UNITED STATES PATENT AND TRADEMARK OFFICE

Office Action Summary	Application No. 10/701,994	Applicant(s) MALLARY ET AL.	
	Examiner Mark Blouin	Art Unit 2627

Detailed Action

FIG. 5

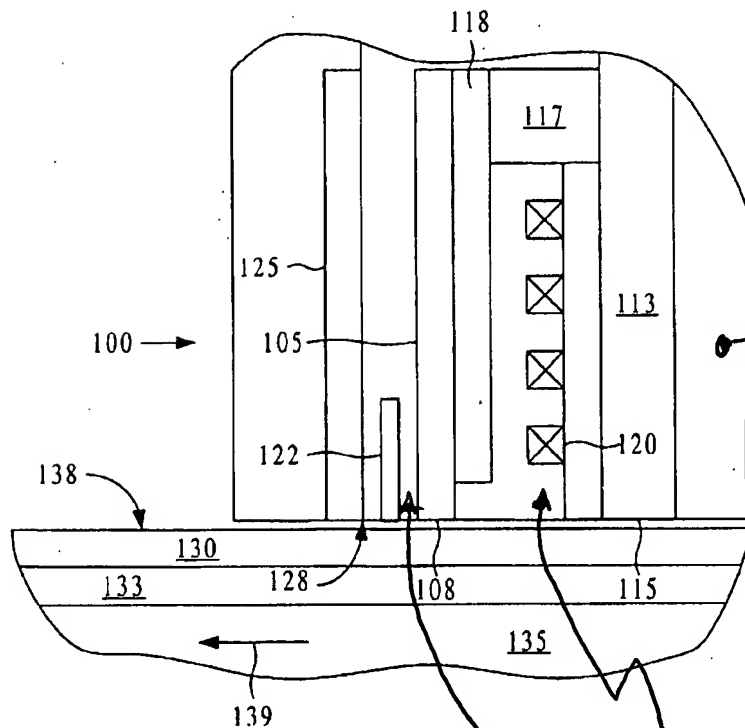
substrate; a second read shield (125) proximate to the first read shield and located on an opposite side of the first read shield from the write pole; a magnetoresistive sensor (122) located between the first and second read shields; and, wherein the first read shield is magnetically connected to the write pole, wherein the distance between the write pole tip and the substrate is less than the distance between the shield and the substrate (see Examiner's Drawing).

8. Regarding Claim 35, Chen et al shows (Figs. 4-8) a read/write head, wherein the write pole (113) is formed directly on the substrate (material to the right of write pole (113) in Figure 5).
9. Regarding Claim 41, Chen et al shows (Figs. 4-8) a read/write head wherein a single uniform layer of insulating material (material that the read sensor is shown to be embedded in – see Examiner's Drawing) separates the write element and read element.
10. Regarding Claim 42, Chen et al shows (Figs. 4-8) a read/write head wherein a region of insulating material (material that coil is embedded – see Examiner's drawing) separates a tip of the write pole from the substrate.

The Examiner maintains that Figure 5 shows the substrate to the right of the write pole tip and the read shield (125) is to the left of the write pole tip (108) thus making the distance of the write pole tip to the substrate less than that of the shield (see Examiner's drawing). Therefore, the rejections of Claims 1,2,8-11,13,17,18,30-33,35, and 39-42 are upheld.

DISTANCE FROM WRITE
POLE TIP TO SUBSTRATE
IS LESS THAN DISTANCE
FROM SHIELD (125)
TO SUBSTRATE
